Re: Florida Power & Light Company
Proposed Turkey Point Units 6 and 7
Docket Nos. 52-040 and 52-041
Response to NRC Request for Additional Information Letter No. 037
(eRAI 5896) SRP Section - 02.05.02 Vibratory Ground Motion

FPL Response to NRC RAI No. 02.05.02-2 (eRAI 5896)

NRC RAI Number: 02.05.02-2 (eRAI 5896)

Re: Florida Power & Light Company
Proposed Turkey Point Units 6 and 7
Docket Nos. 52-040 and 52-041
Response and Response Schedule to NRC Request for Additional Information
Letter No. 037 (eRAI 5896) SRP Section - 02.05.02 Vibratory Ground Motion

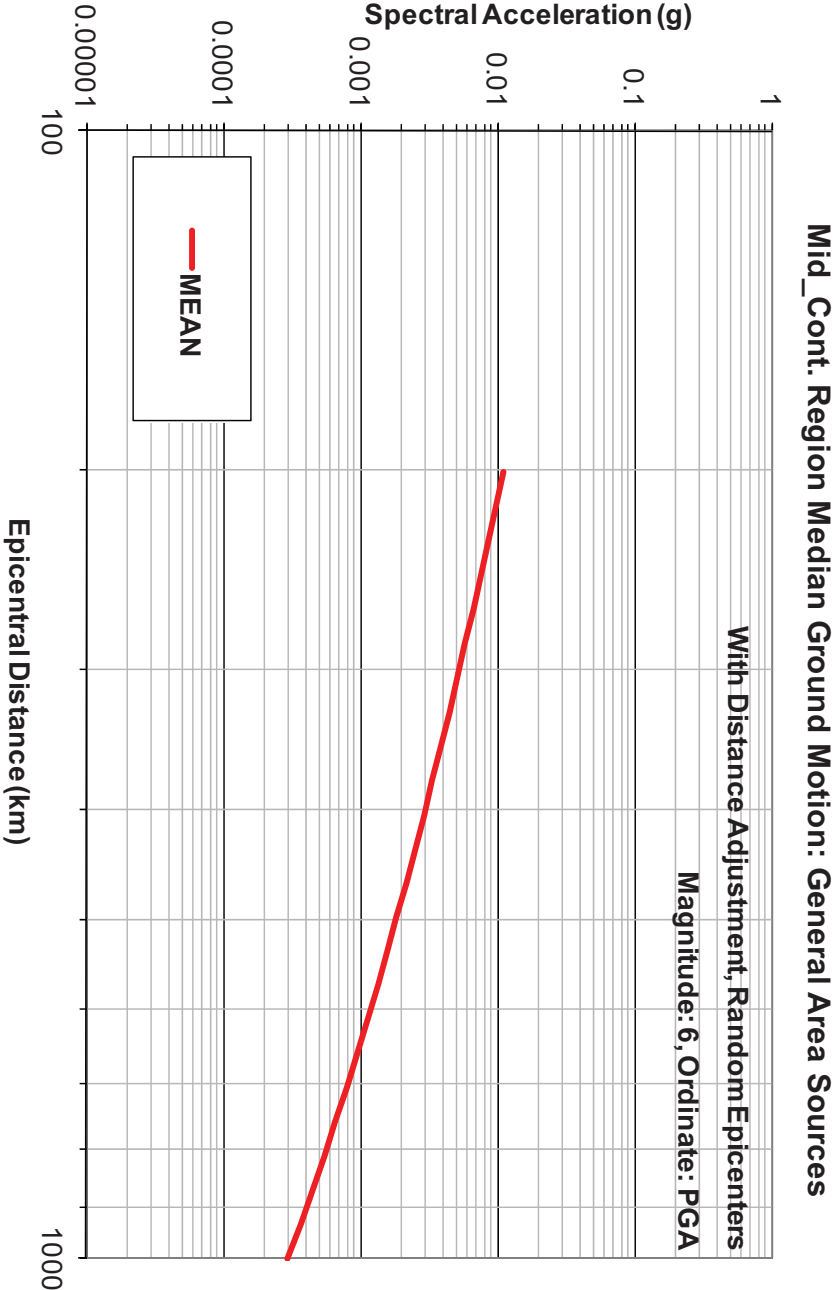
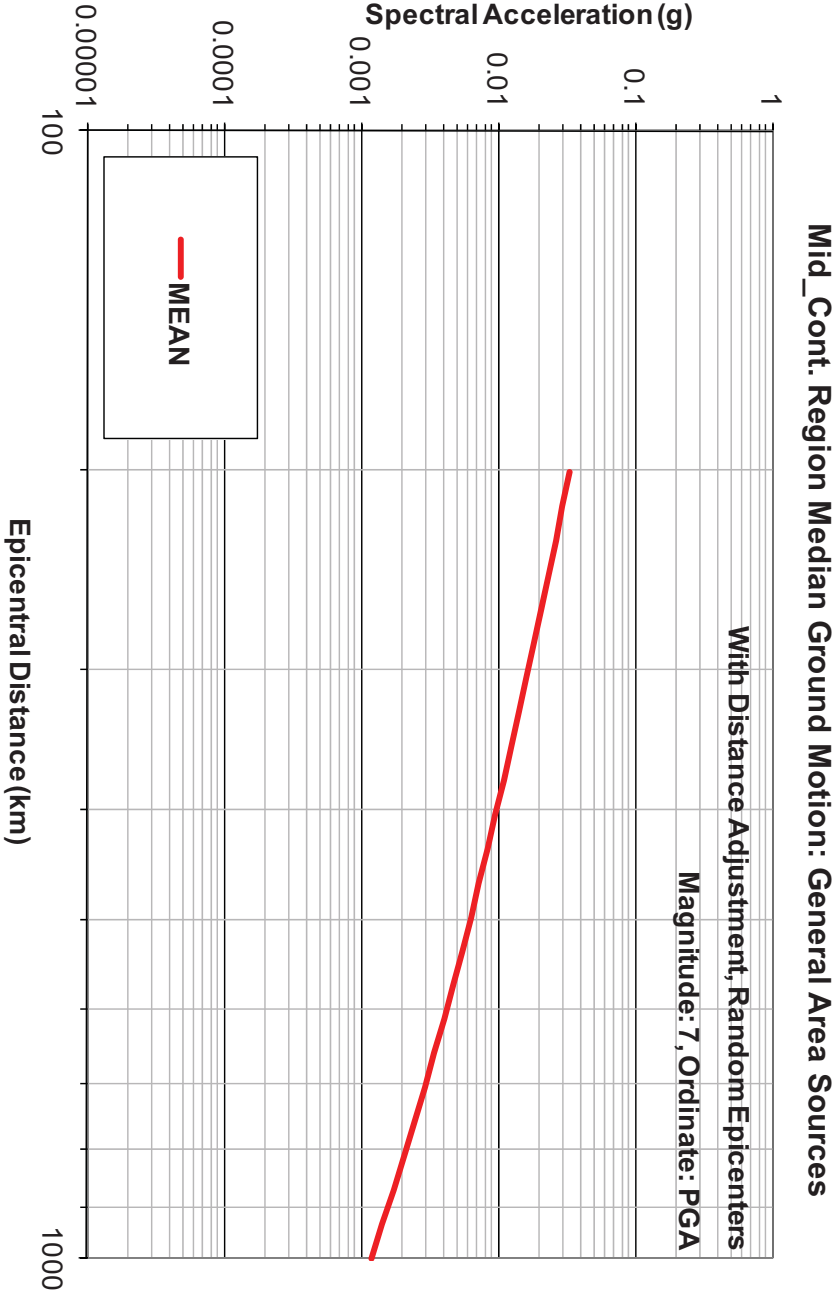
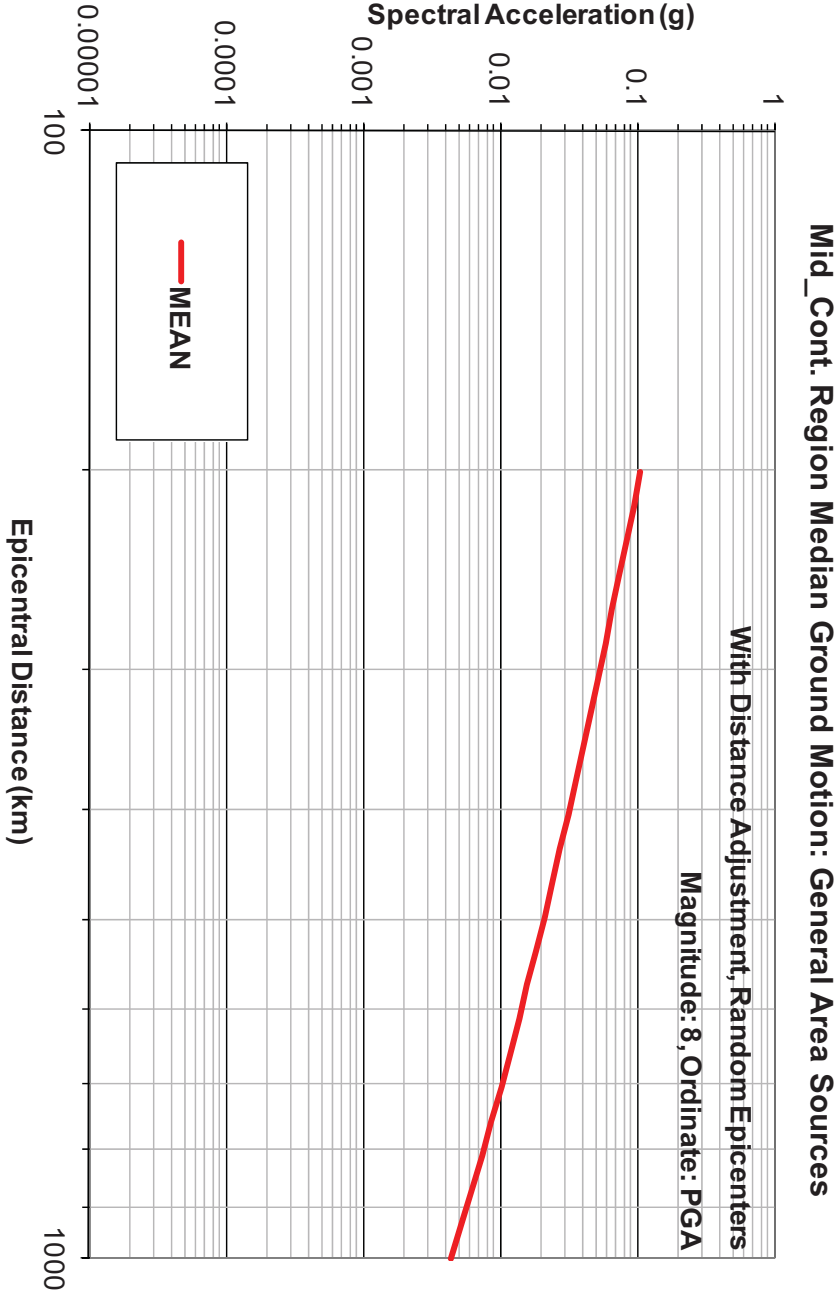
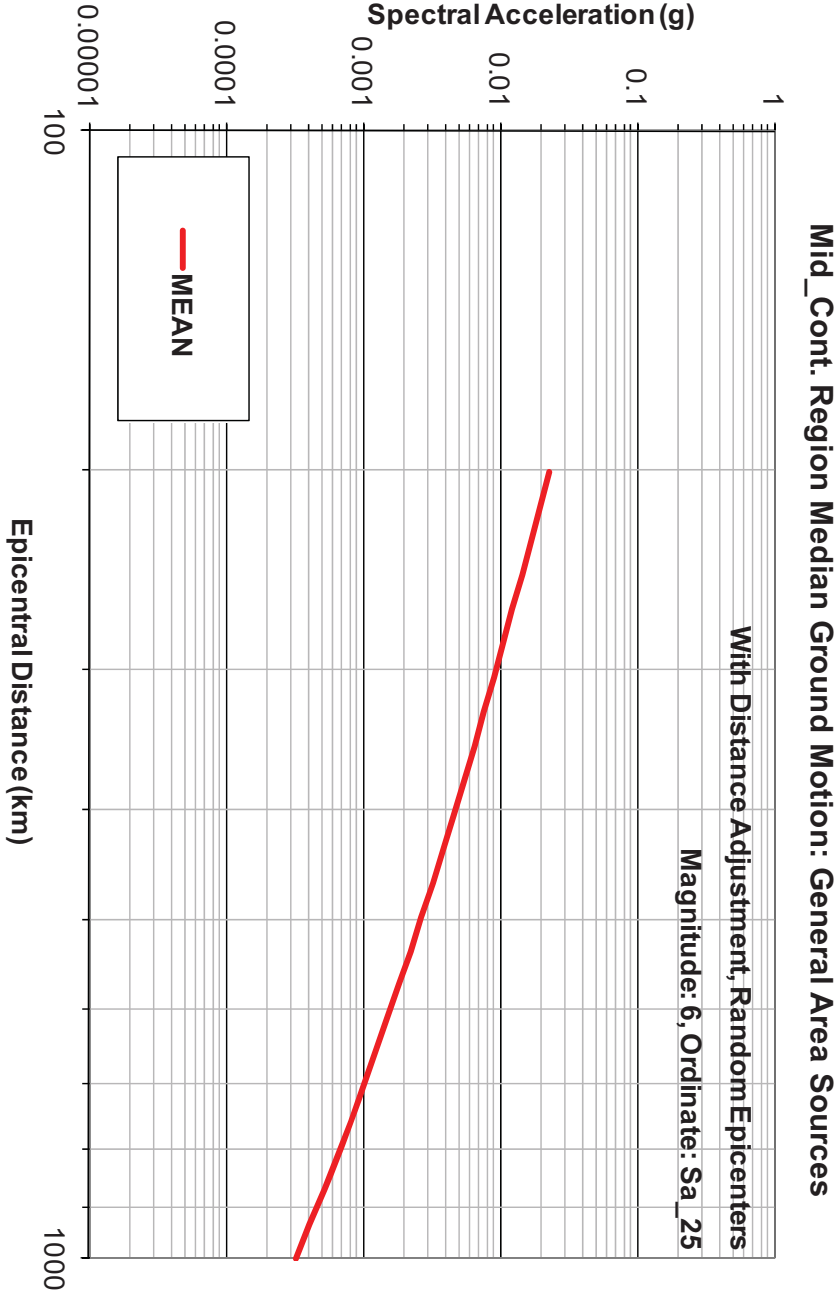
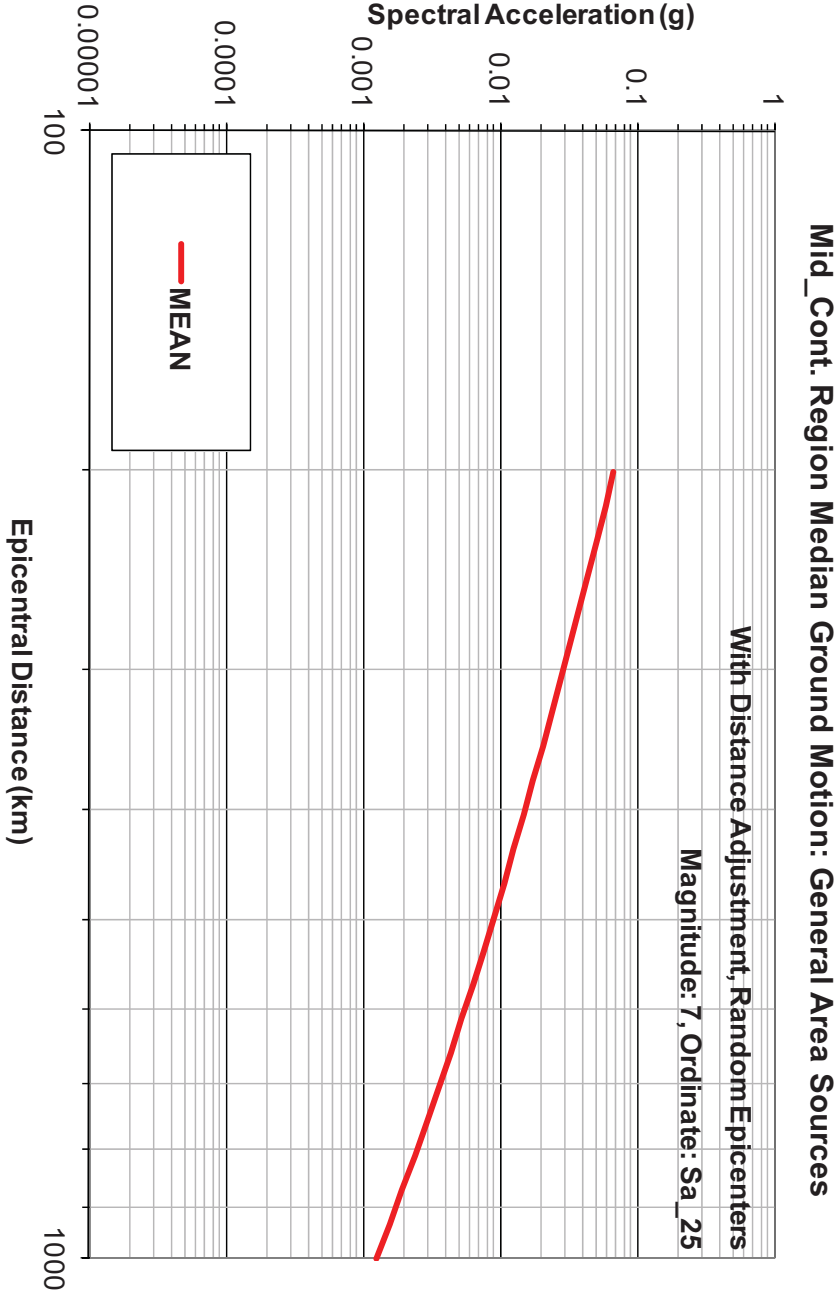
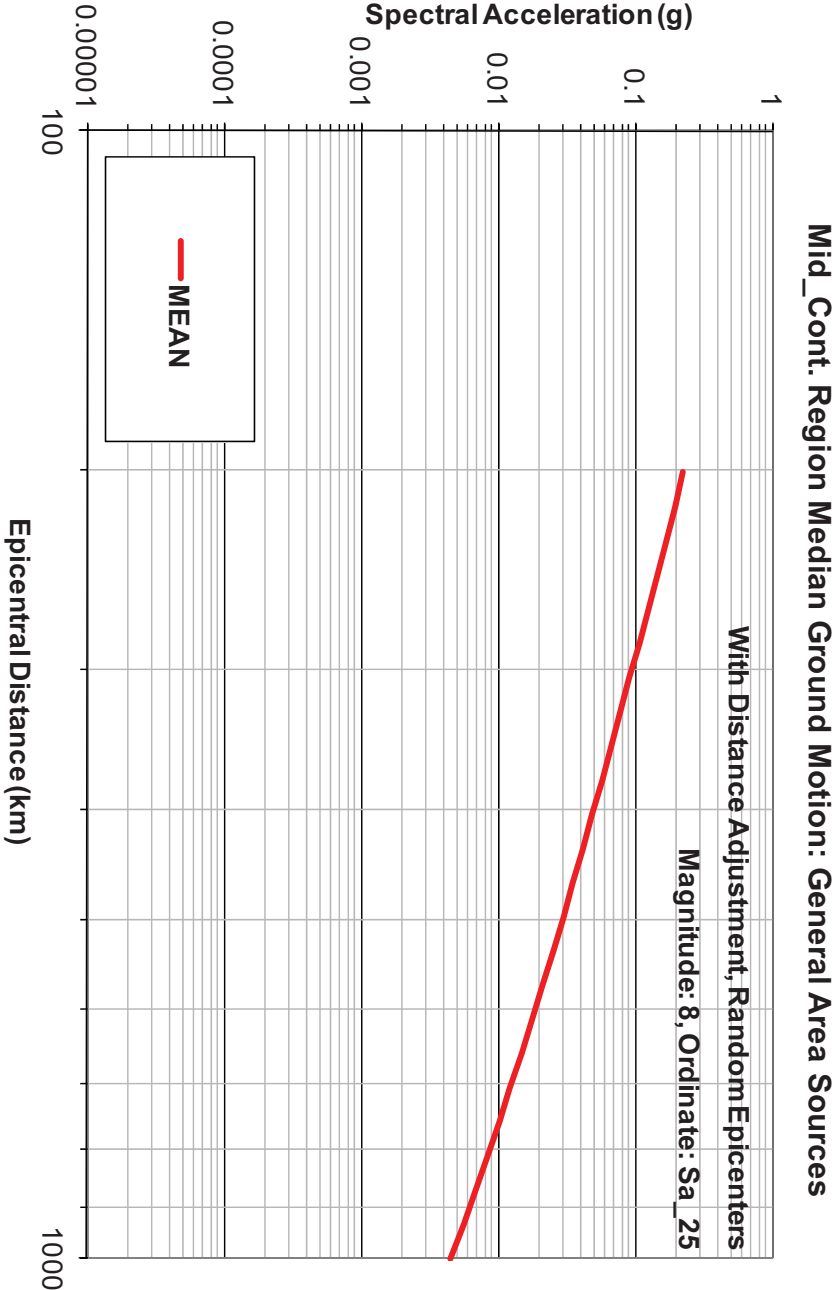
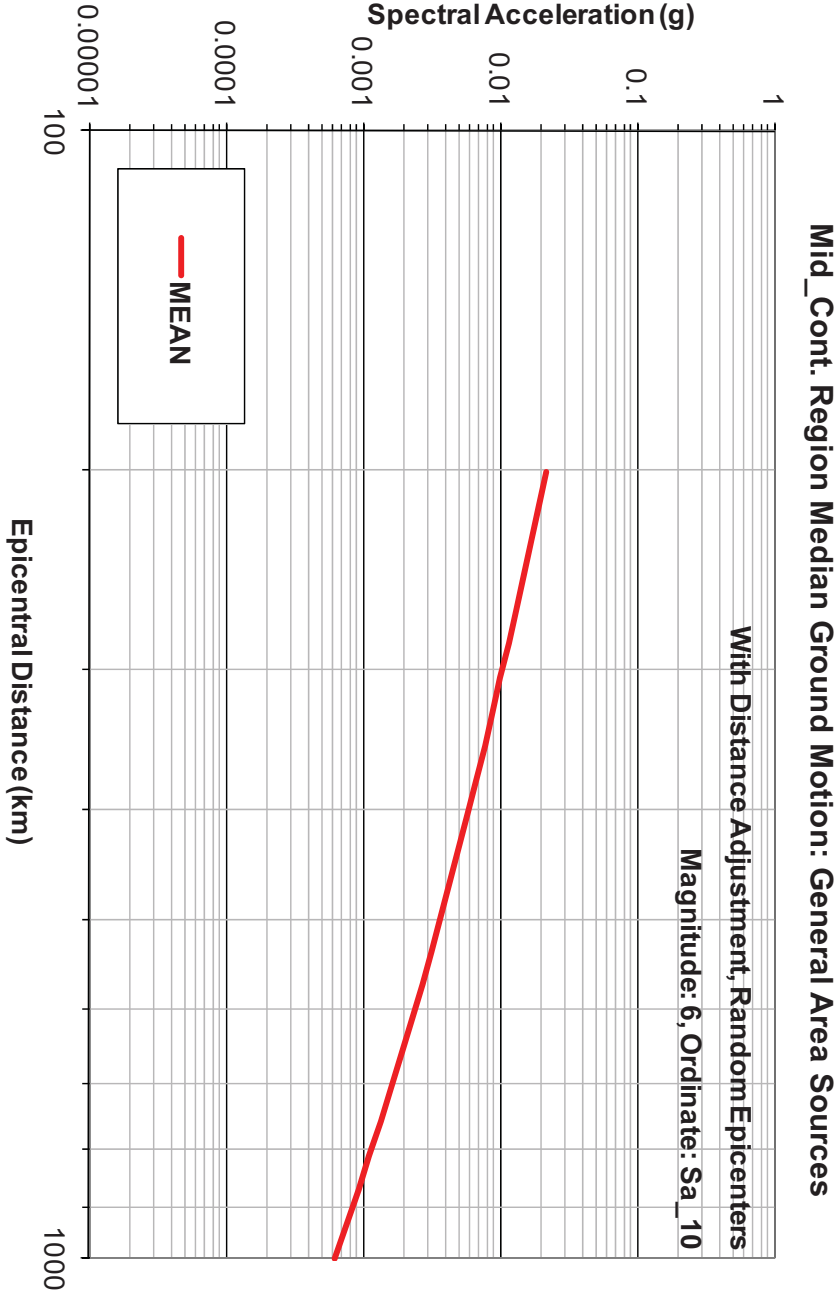
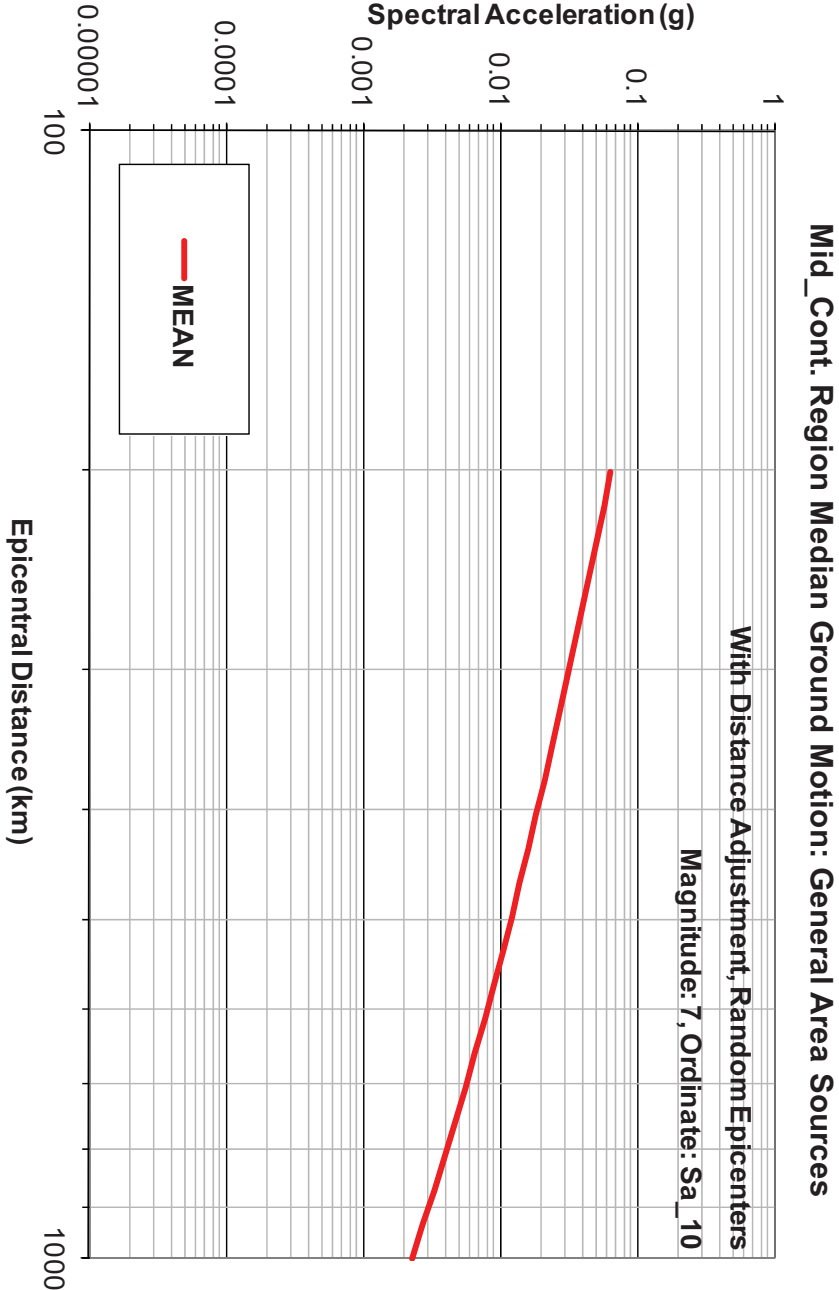
- d. In order for the staff to be able to compare the new Caribbean GMPEs with the 2004/2006 EPRI mid-continent GMPEs, please provide plots showing both ground motion models for earthquake magnitudes of 6.0, 7.0, and 8.0 in the distance range of 200 km to 1000 km at all seven frequencies defined in the EPRI 2004 and 2006 GMPEs.

Ground motion attenuation curve plots are provided for the EPRI (FSAR References 242 and 203) and Caribbean ground motion prediction equations (GMPEs). Note that EPRI (FSAR Reference 203) is only a recommendation for the associated aleatory uncertainty and therefore does not impact the comparison plots of the weighted mean ground motion

attenuation curve. The plotted mean attenuation curve is the weighted mean of the individual median attenuation curves as defined in EPRI (FSAR Reference 242). These attenuation plots are provided for three specific moment magnitude (M_w) values: 6, 7, and 8 for distances between 200 km and 1,000 km. Note that the EPRI (FSAR Reference 242) ground motion attenuation model is defined as a function of epicentral distance, whereas the Caribbean ground motion attenuation model is defined as a function of hypocentral distance. However, because the closest distance is 200 km, the difference between the epicentral and hypocentral distances would be less than 1% for a typical crustal depth of 10 km and even smaller for larger distances out to 1,000 km.

The weighted mean ground motion attenuation curves for the EPRI (FSAR Reference 242) model are given in Figures 1 through 7 for the three magnitudes and seven spectral frequencies requested in the RAI. The weighted mean Caribbean ground motion attenuation curve plots for the same suite of magnitudes, distances, and spectral frequencies are shown in Figures 8 through 14.
